New Albany Planning Commission
Monday, June 3, 2024 Meeting Minutes - Approved

FDP-22-2024 Final Development Plan

**PANDA EXPRESS
FINAL DEVELOPMENT PLAN**

project name Panda Express
 prepared for City of New Albany
 date May 16, 2024
 date received April 29, 2024

Proposed Site Plan

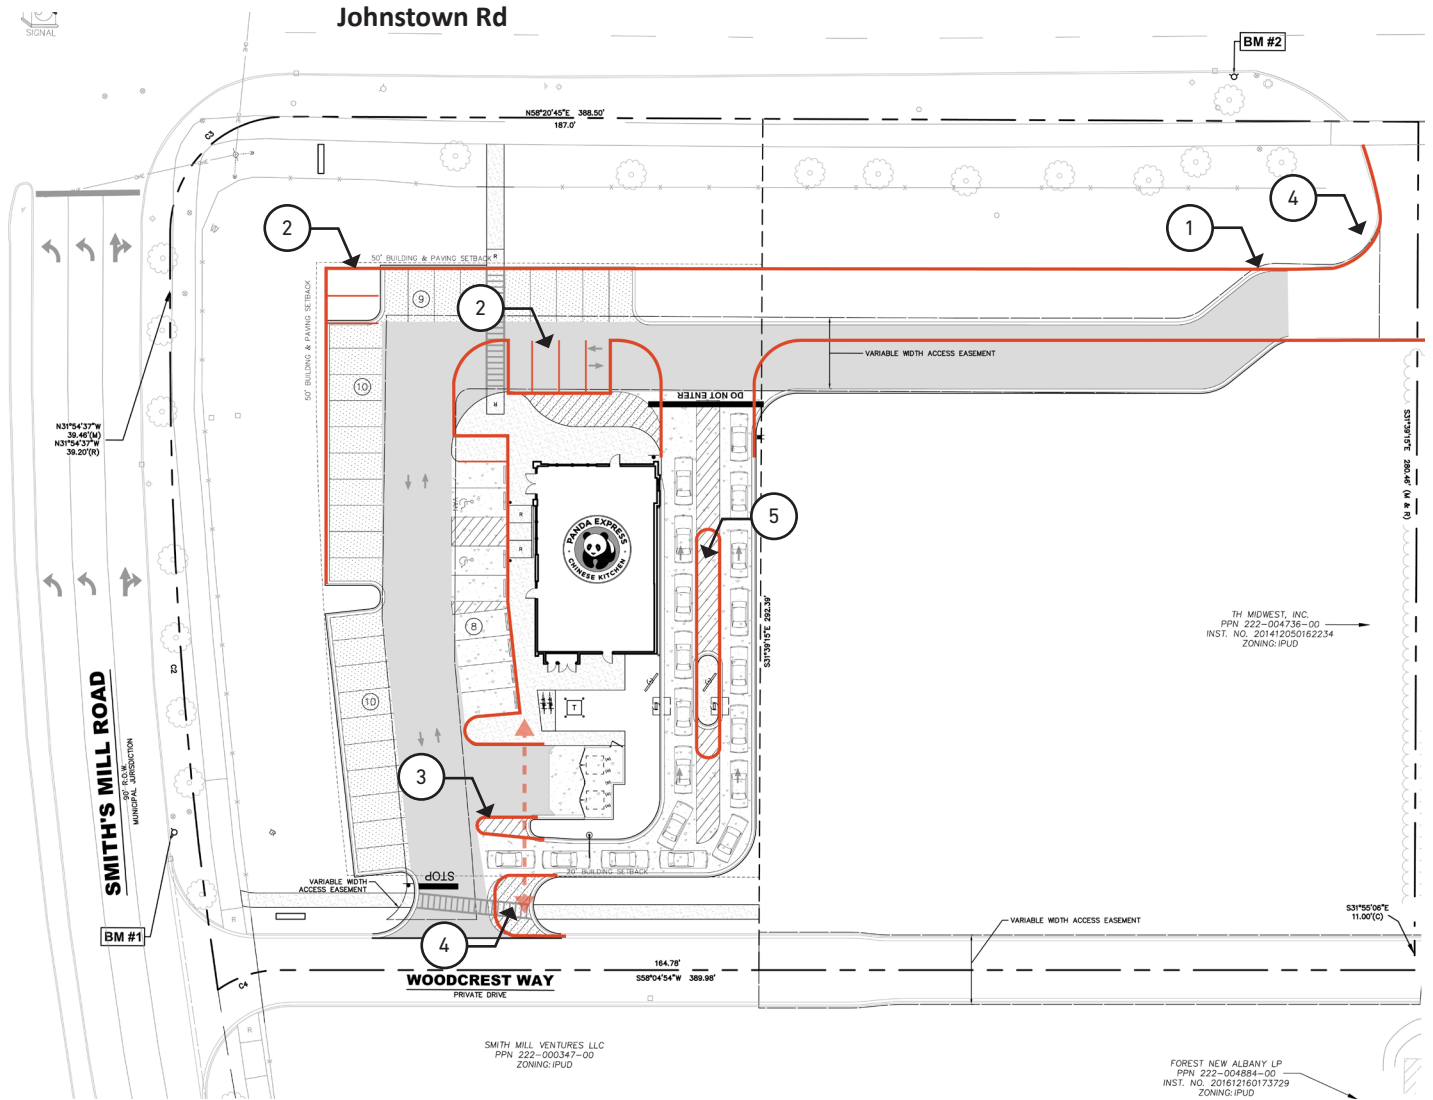
Site Plan

1. Realign the access drive adjacent Johnstown Road to create a consistent transition from the existing drive at the neighboring parcel. See diagram.
2. Realign the proposed parking to follow the building and pavement setback with the shifted access drive, and accommodate minimum parking requirements. See diagram.
3. Reevaluate curb alignment at drive-through entrance. Minimize pavement and striping conditions where possible. See diagram.
4. Consider a safe pedestrian connection into the site from the proposed sidewalk along Woodcrest Way. Recommend considering a future pedestrian connection from the drive at Johnstown Road to connect with the adjacent parcel.
5. Extend the drive-through lane median to reduce pavement and extend landscape planting zone. See diagram.

Proposed Planting Plan

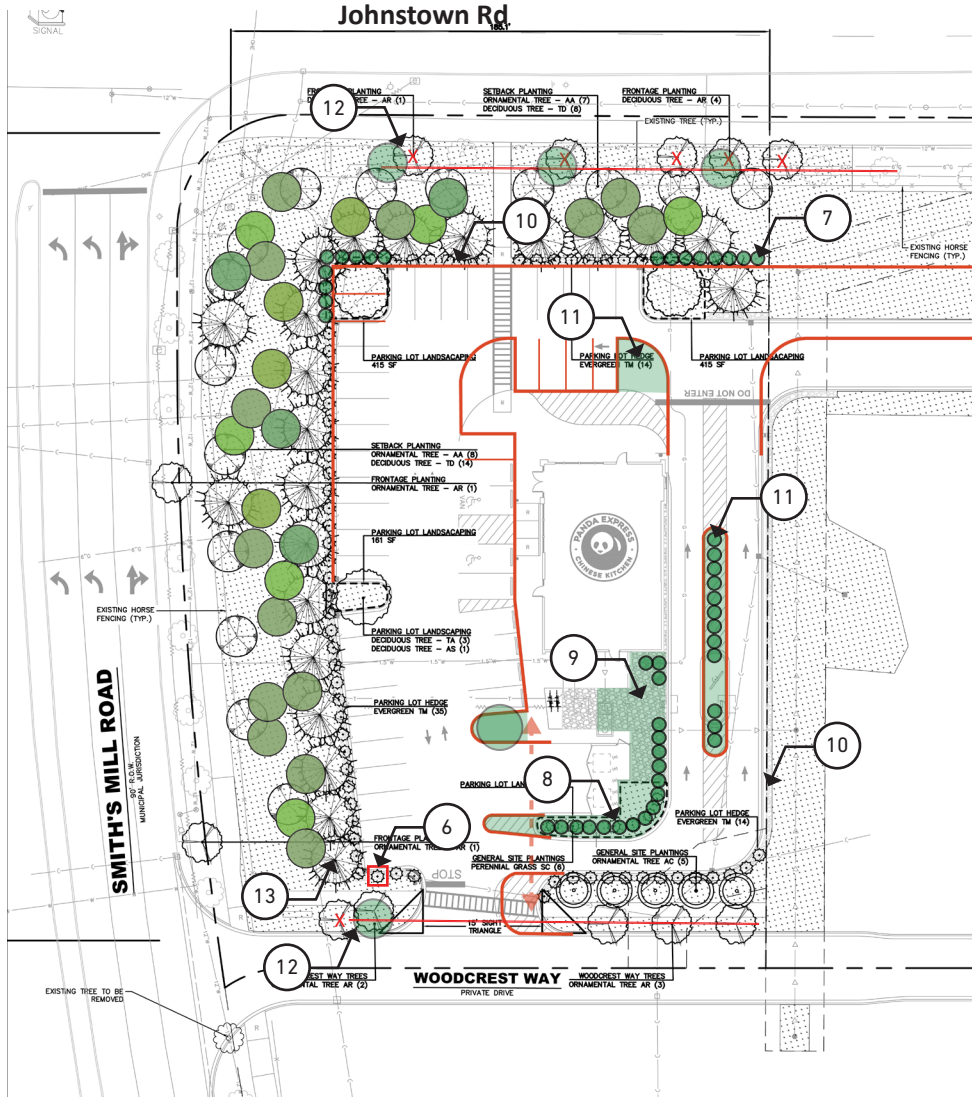
Planting Plan

6. Update planting legend and labels to properly reflect proposed plant material. Current plan symbols misrepresent deciduous shrubs along parking lot to be perennial grass. Resubmit updated plant list. See diagram.

9. Remove the use of rock beds along the drive-through. Extend plant bed and material along the drive-through lanes to match existing conditions present in other sites within New Albany.

10. Remove use of rock beds at edge of pavements. Replace with lawn or mulched planting beds where applicable. See diagram.
11. Include planting in proposed curb extensions. See diagram.

12. Realign trees along Johnstown Road and Woodcrest Way as marked. Placement to be evenly spaced and aligned along both sections. See diagram.
13. Replace use of Bald Cypress (*Taxodium Distichum*) along the parking lot with a deciduous shade tree. Recommend use of one of the following... *Liriodendron tulipifera*, *Nyssa sylvatica*, *Platanus x. acerfolia*, *Gymnocladus dioicus*. Tree placement should adhere to tree grouping standards seen below. Resubmit updated plant list. See diagram.
